Proposed Amendment to DA24-O24 - Hotel and Restaurant Lot 2654 (No. 275) Bayview Road, Gap Ridge

RFF Australia acts on behalf of QSD Hire Pty Ltd with respect to the development of the Bayview Hotel and Restaurant, at Lot 2654 (No. 275) Bayview Road, Gap Ridge ('the subject land'). We are pleased to submit this application for an Amendment to the existing Development Approval (DA24-O24) that seeks to amend the general layout of the development within the front portion of the site (hotel bar, restaurant and supporting amenities).

This Application seeks to amend the existing Development Approval of the City of Karratha for minor amendments to the approved site plan. The amendments are concentrated in the front portion of the site, and are summarised as follows:

PROPOSED AMENDED PLAN
RESTAURANT - FLOOR PLAN

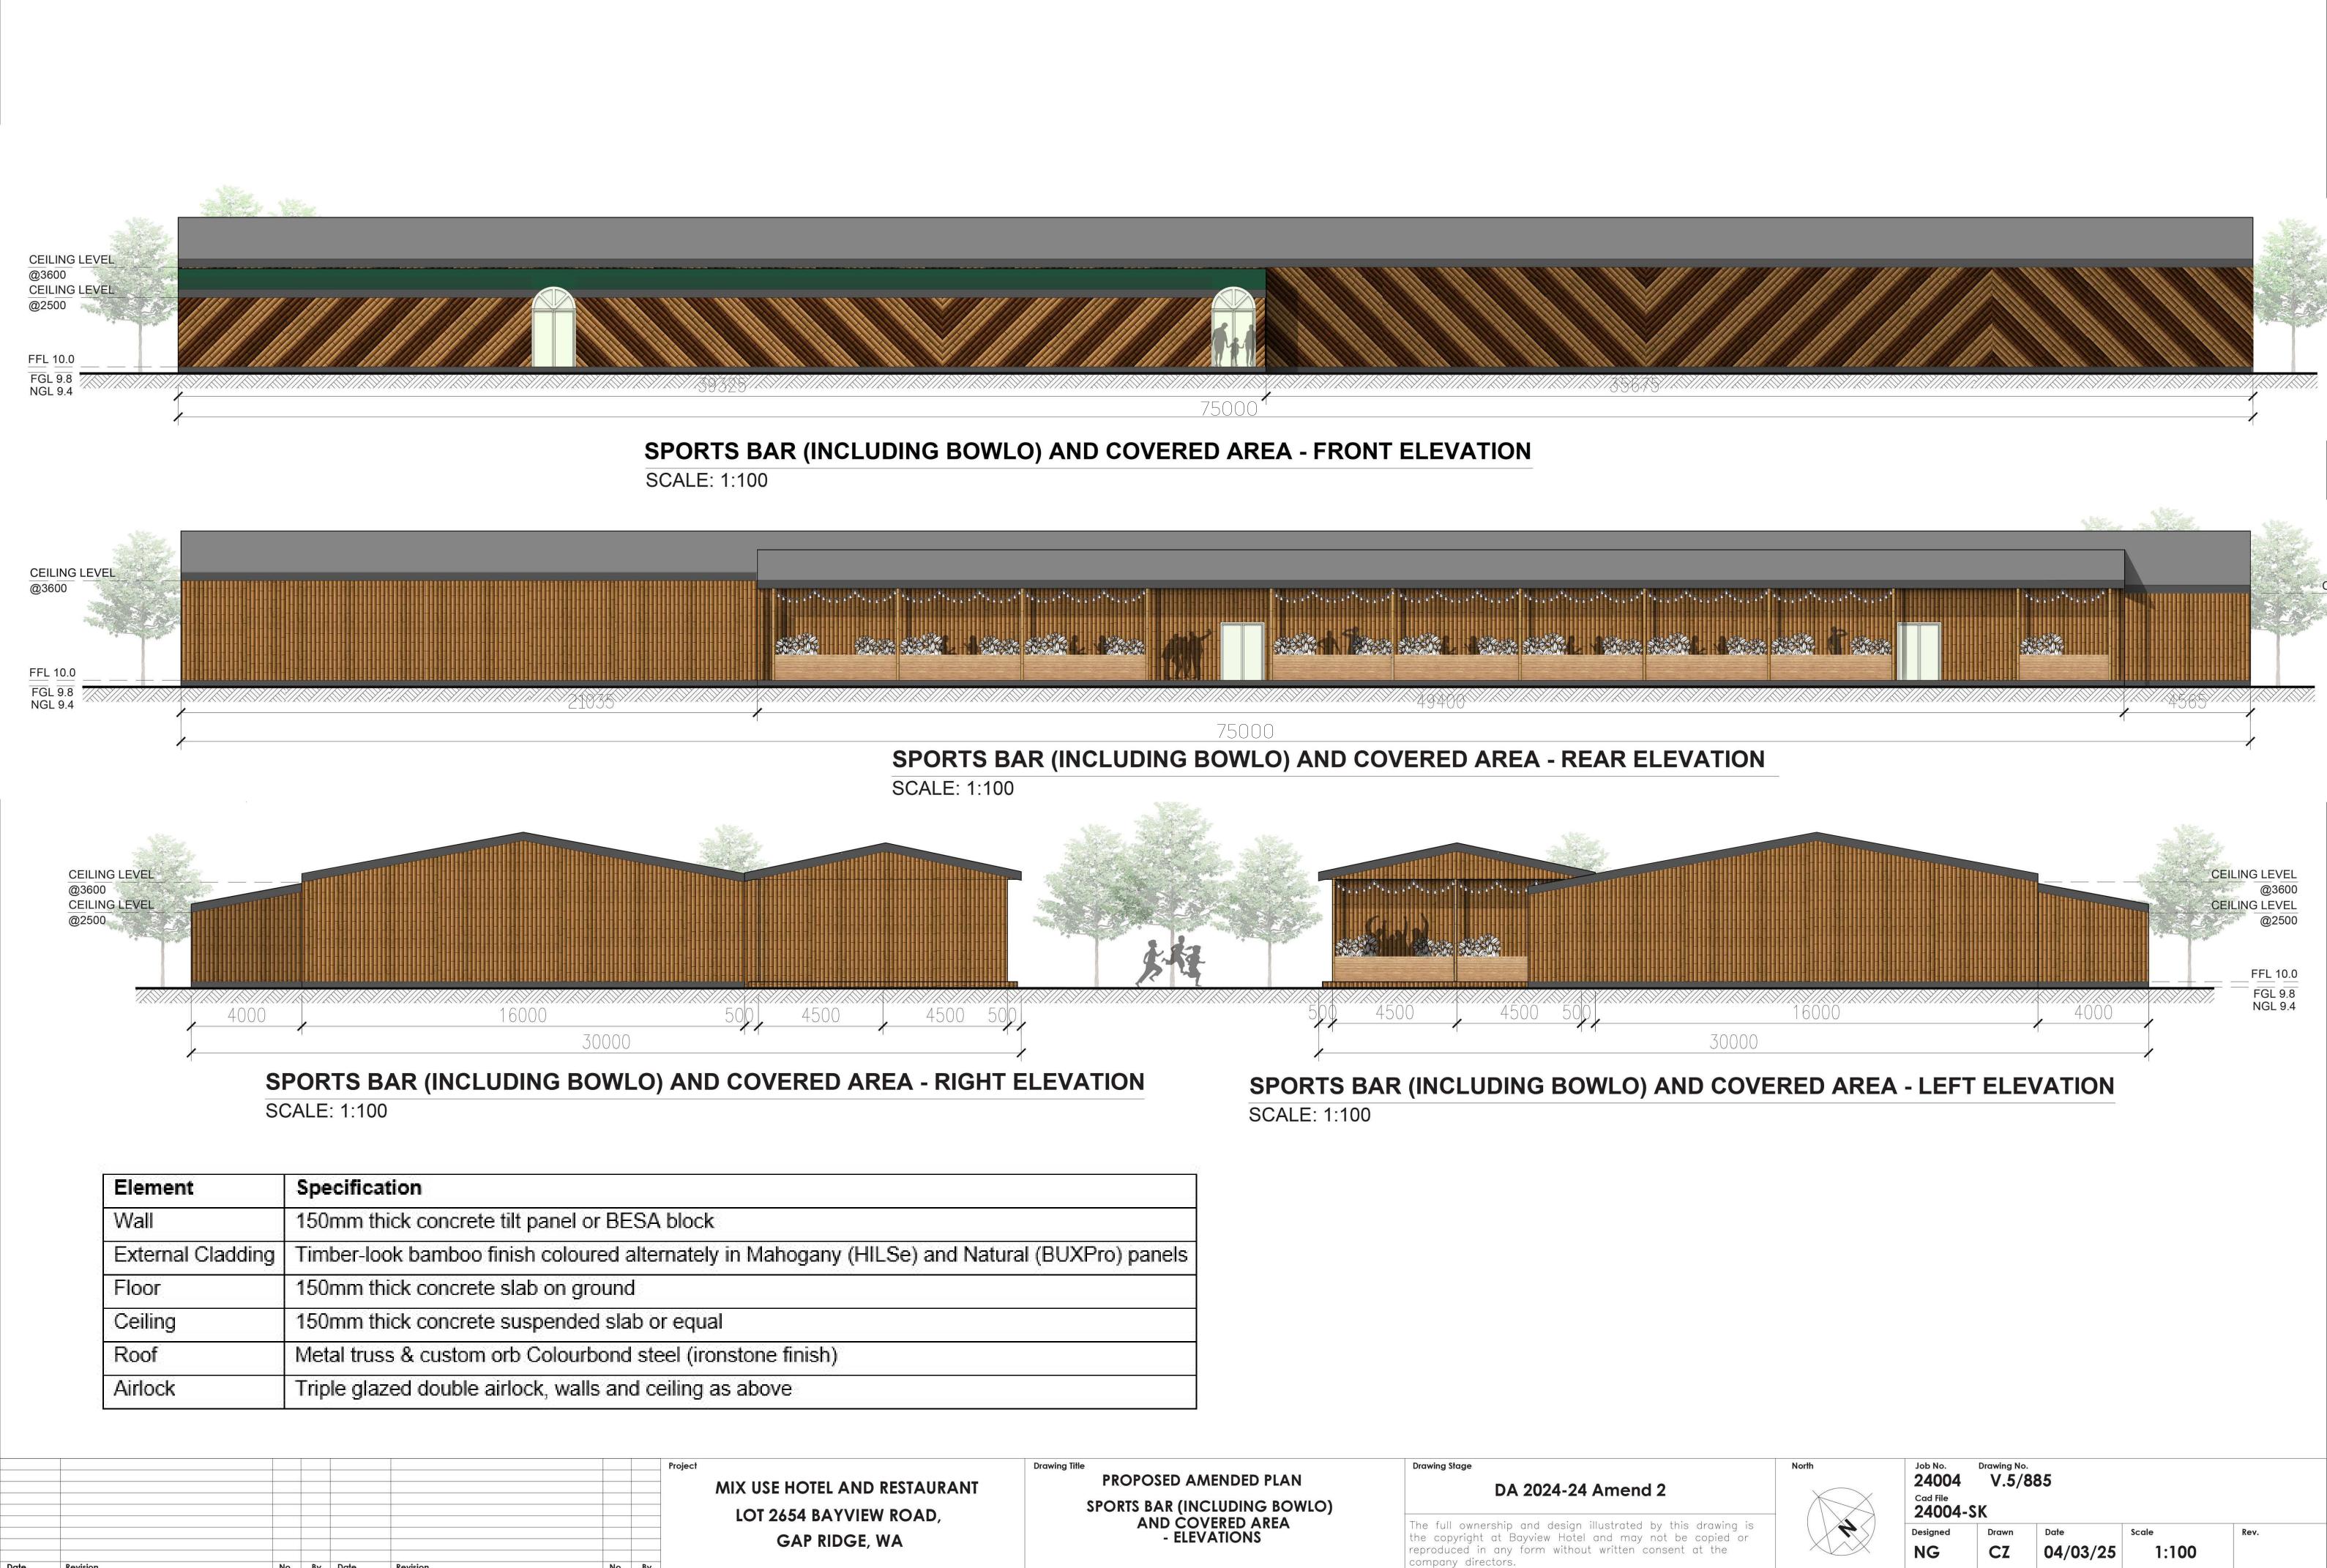
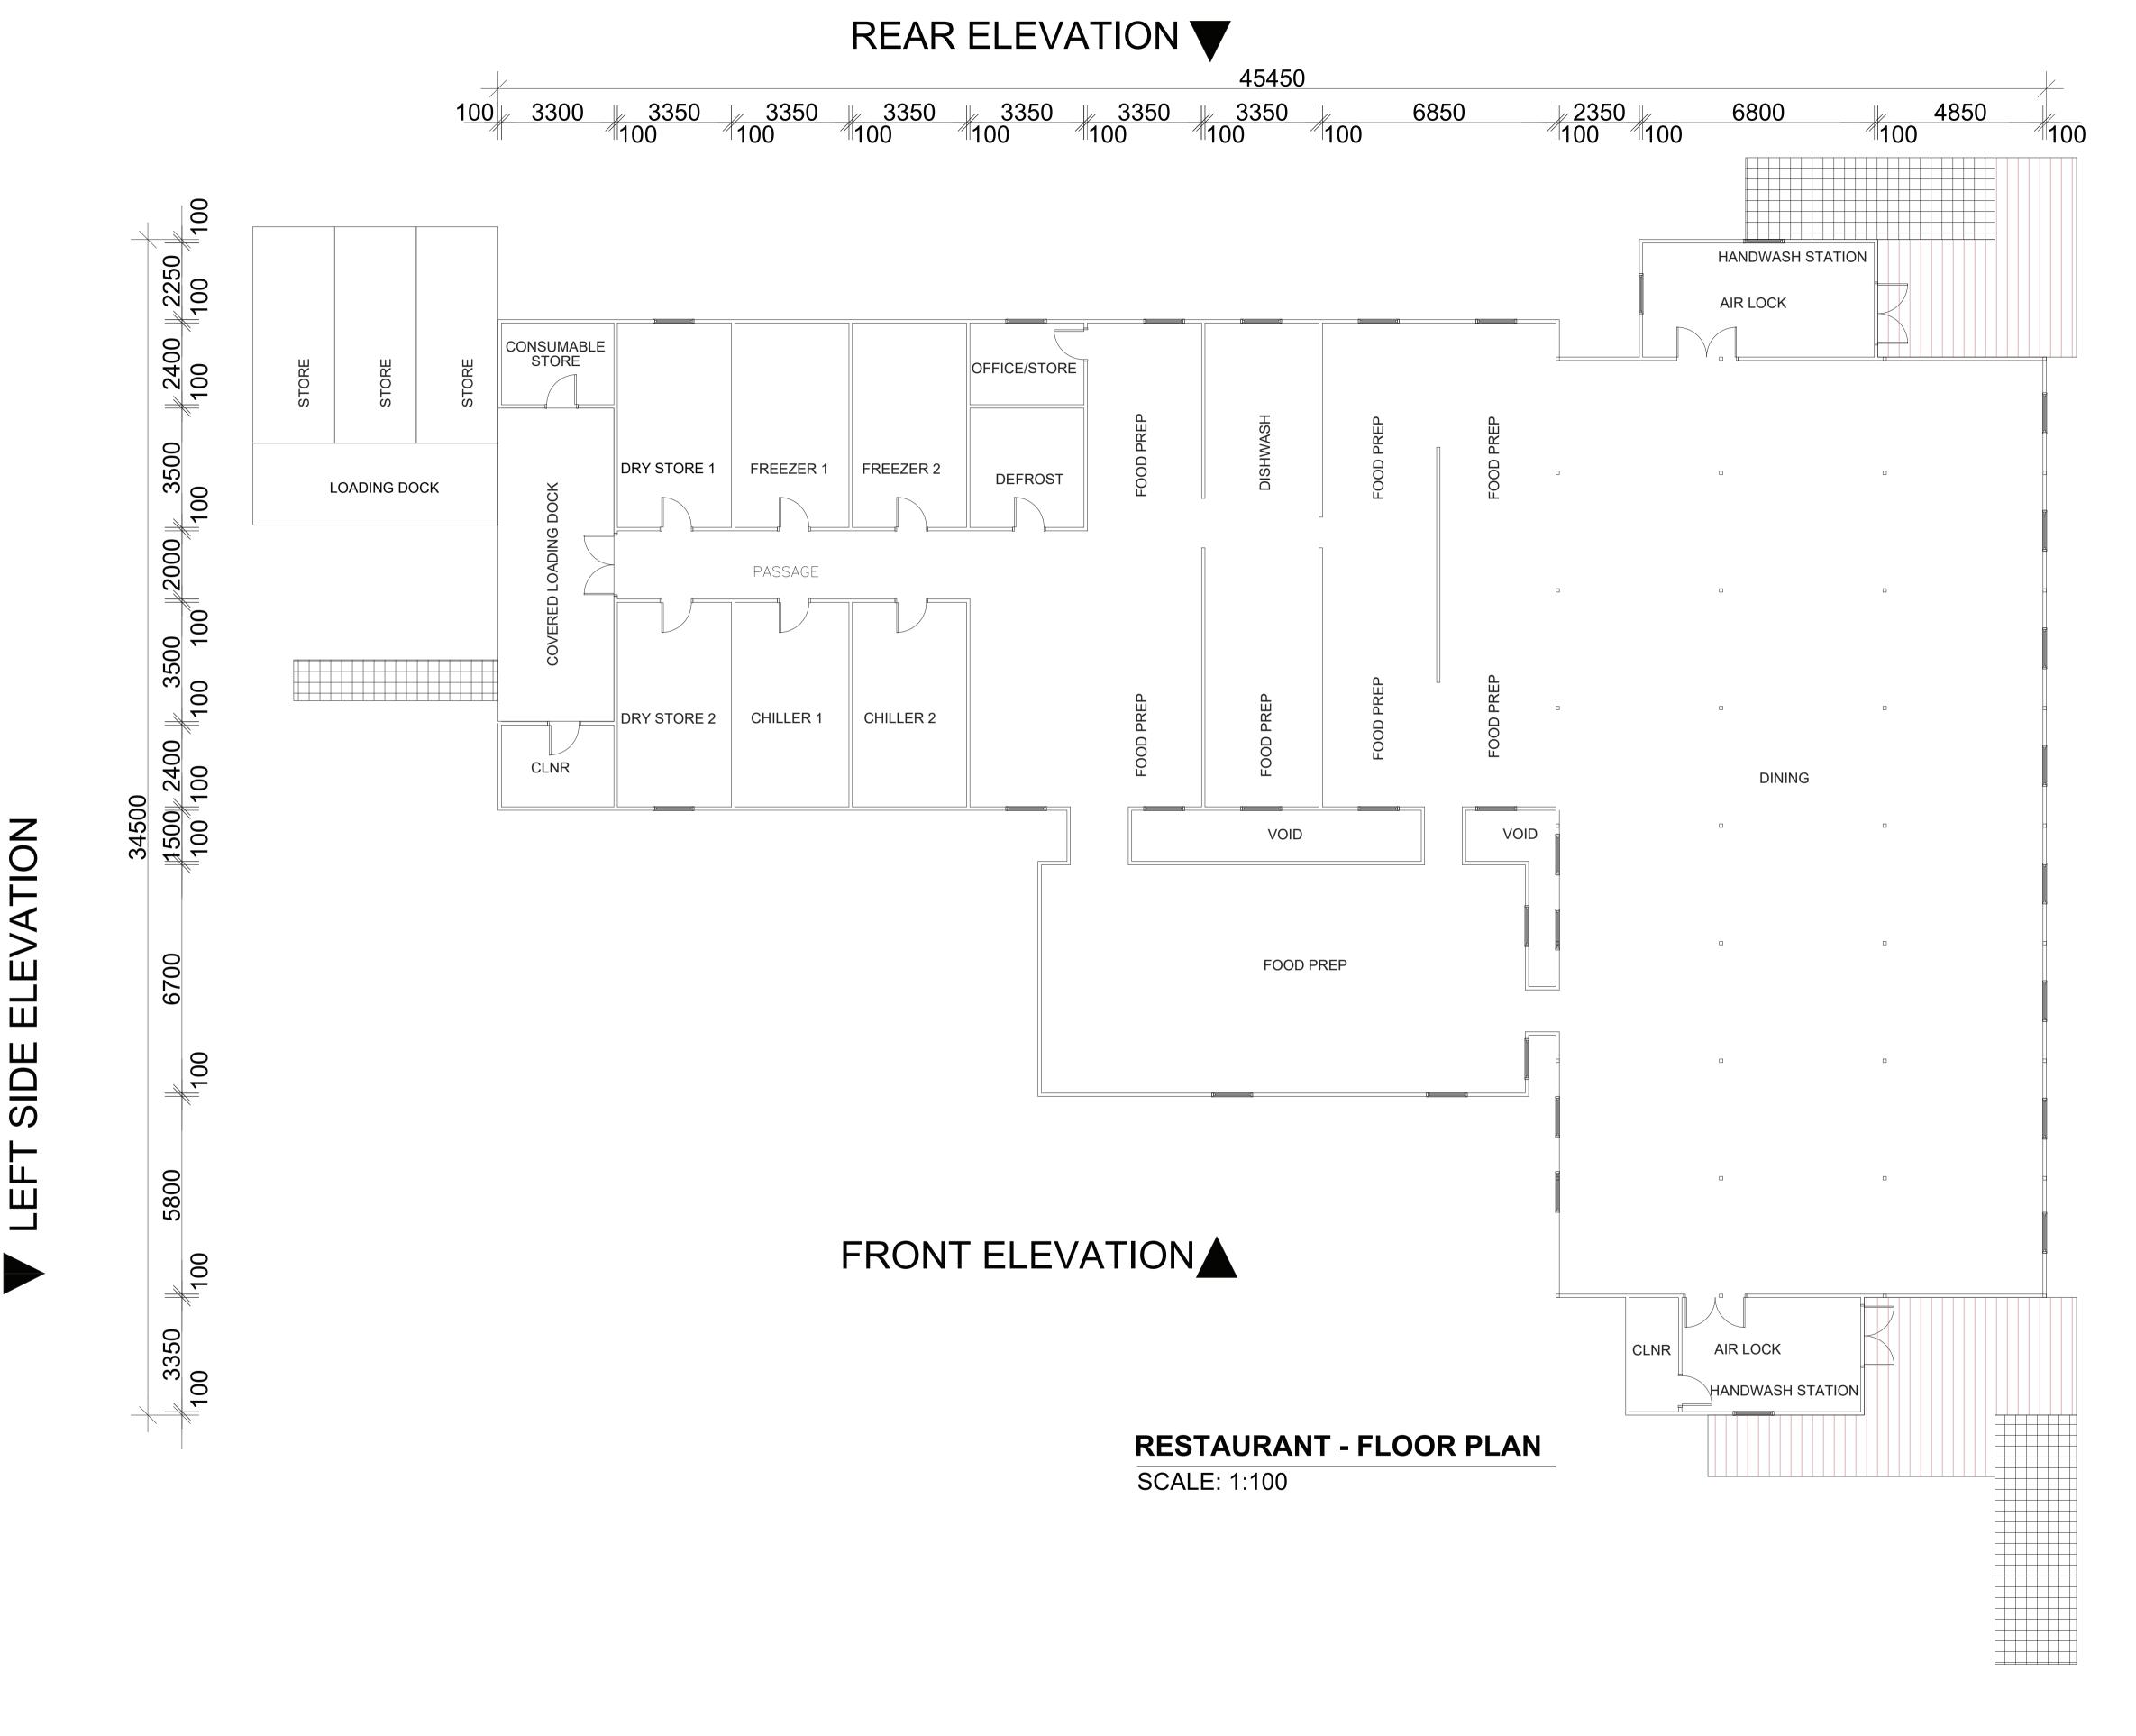
Restaurant:

- Restaurant to be located on the north-west side of entry driveway; and which is intended to provide a family friendly dining experience (i.e., will not be a liquor licensed premises).
- Building reconfigured as required by operator.

PROPOSED AMENDED PLAN STORAGE & ABLUTION BLOCK - FLOOR PLAN & ELEVATIONS

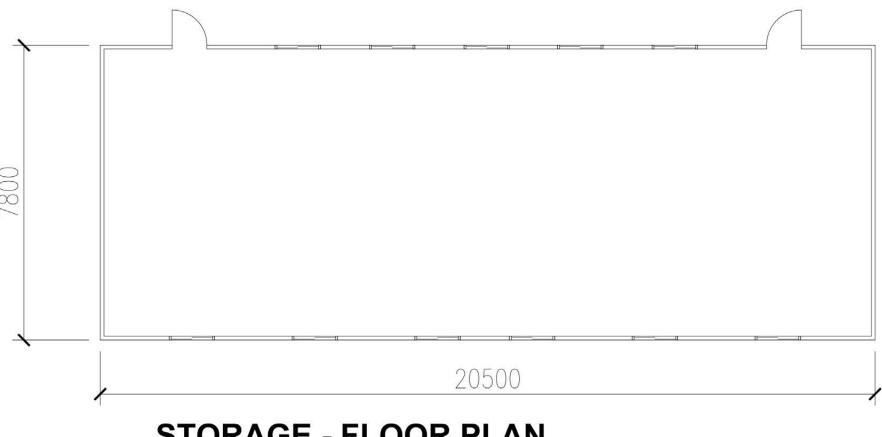
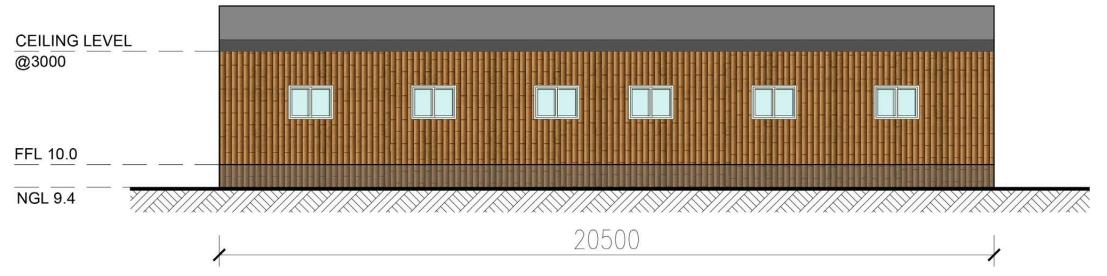
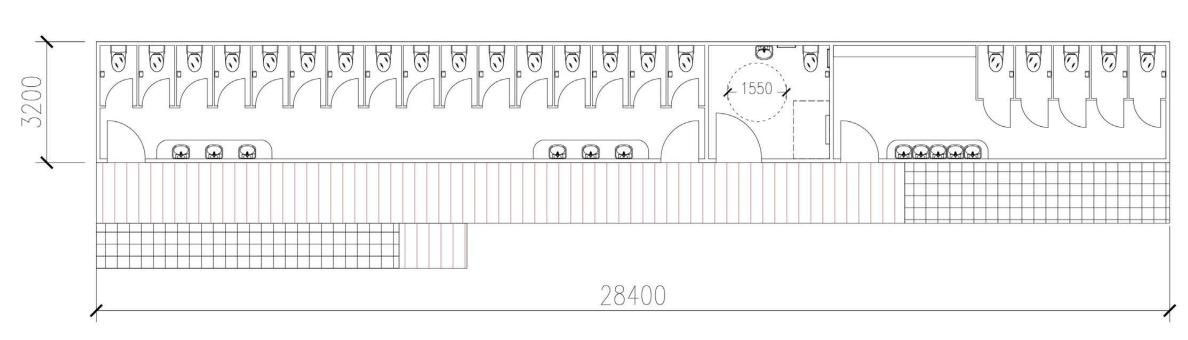
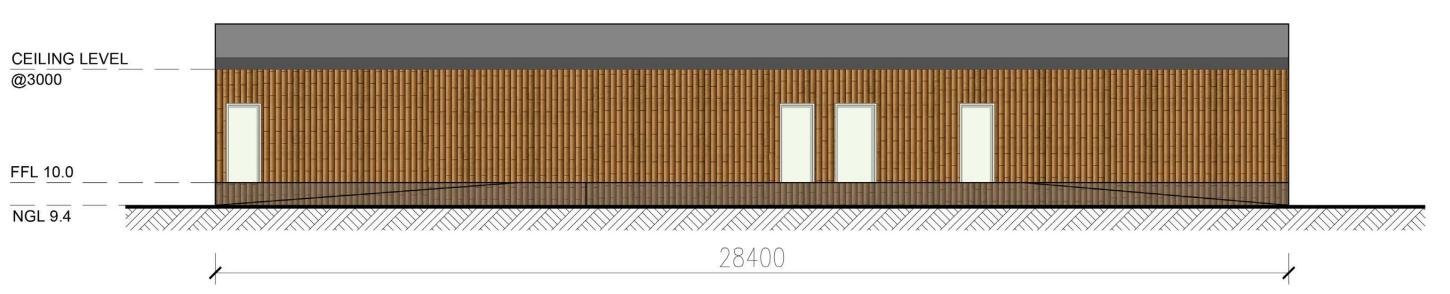
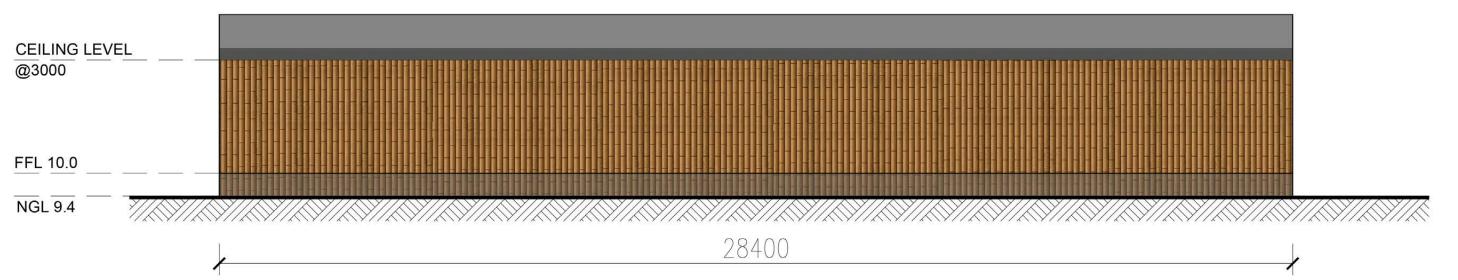
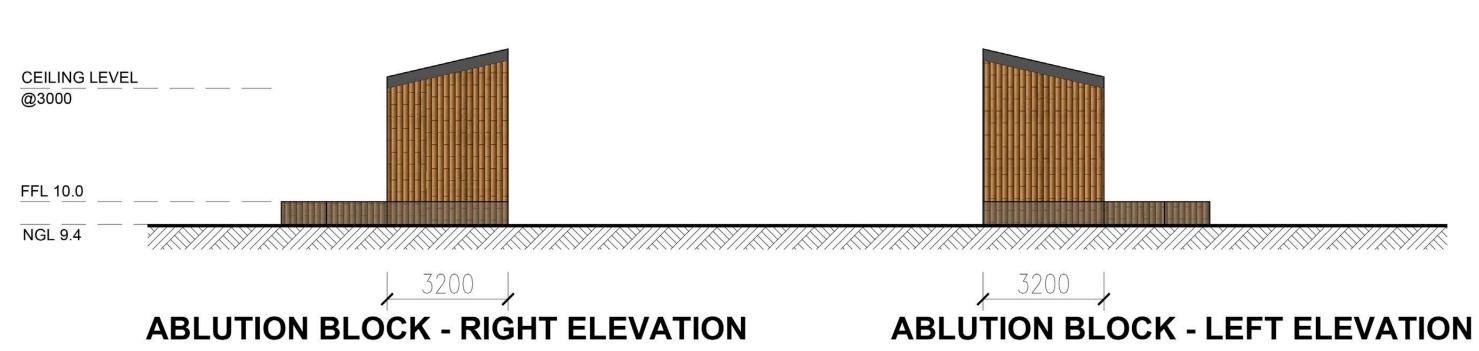
- Relocation of ablution facilities and storage area to be generally centrally focussed in proximity to the existing reception facility.
